## ORIGINATION FORM

Proposed Revisions to a Standard Plans Index  
(Please provide all information — Incomplete forms will be returned)

Index Number: 715-003  
Sheet Number (s): 3  
Index Title: UTILITY CONFLICT POLE

INDEX 715-003	SHEET 3 of 3
------------------	-----------------

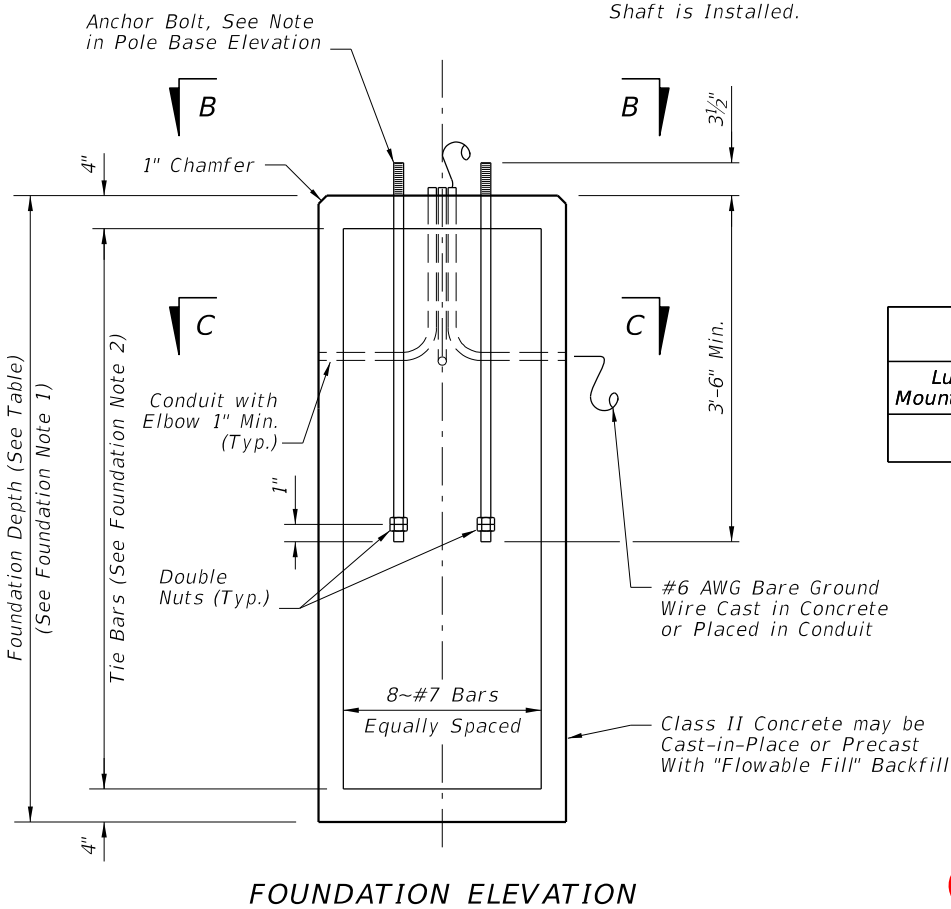
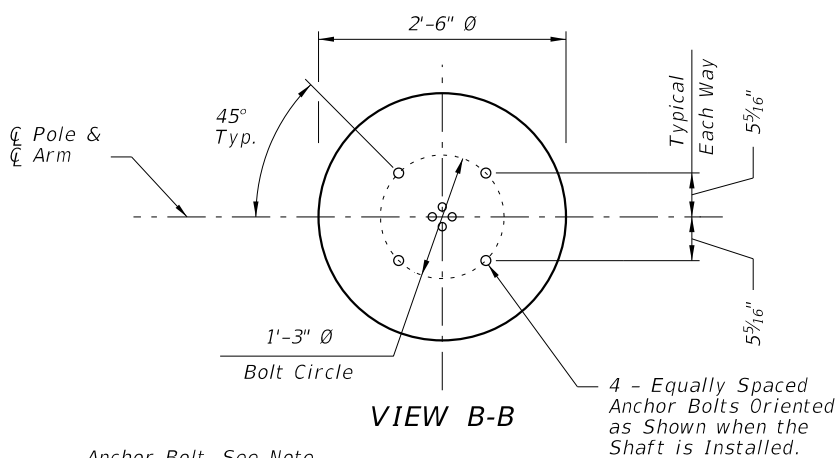
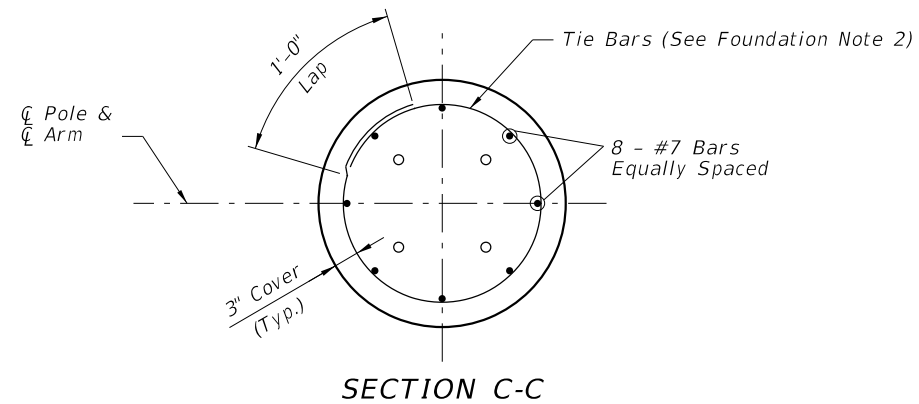
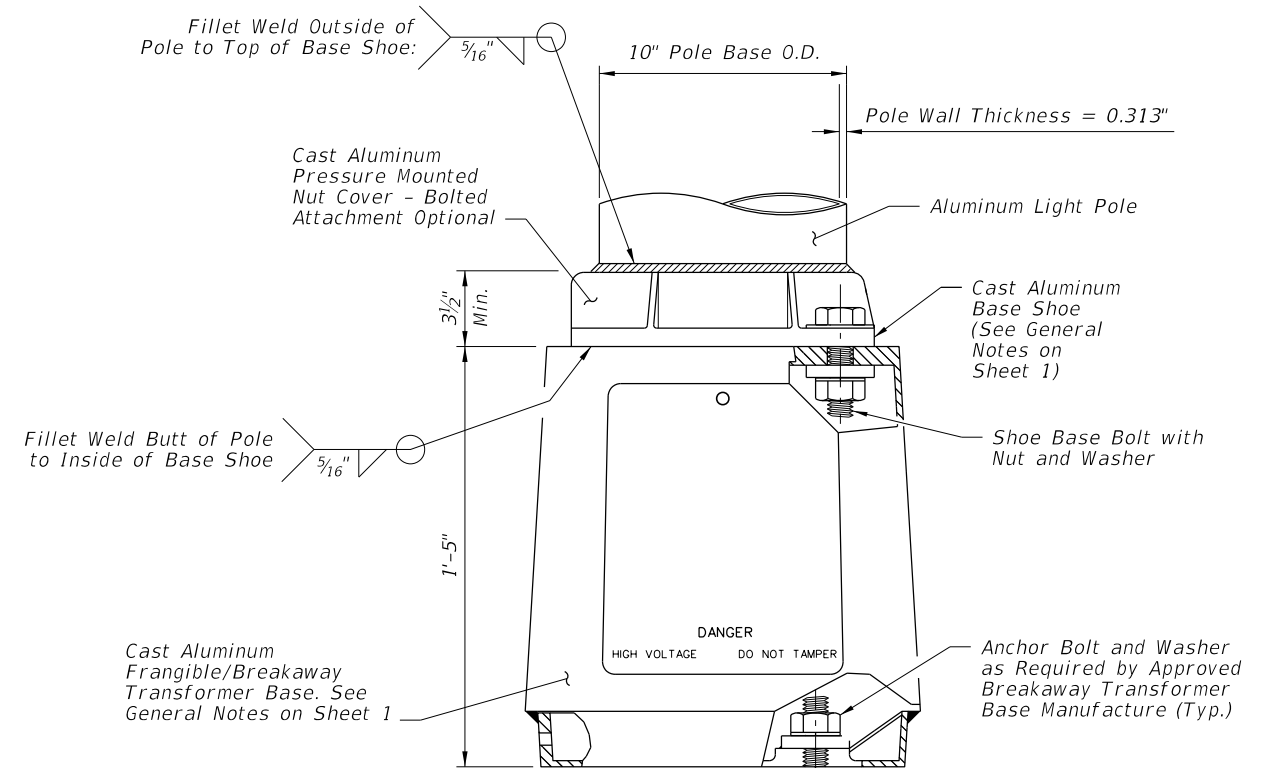
Sheet 3: Added Foundation Note 3 to allow for precast foundation with an octagon shape as a substitute for the circular shaped foundation shown.

Sheet 3: A non-circular, octagon shaft foundation option was requested by industry to simplify formwork.

Added Note 3 for Precast Octagon Shaped Foundation Option
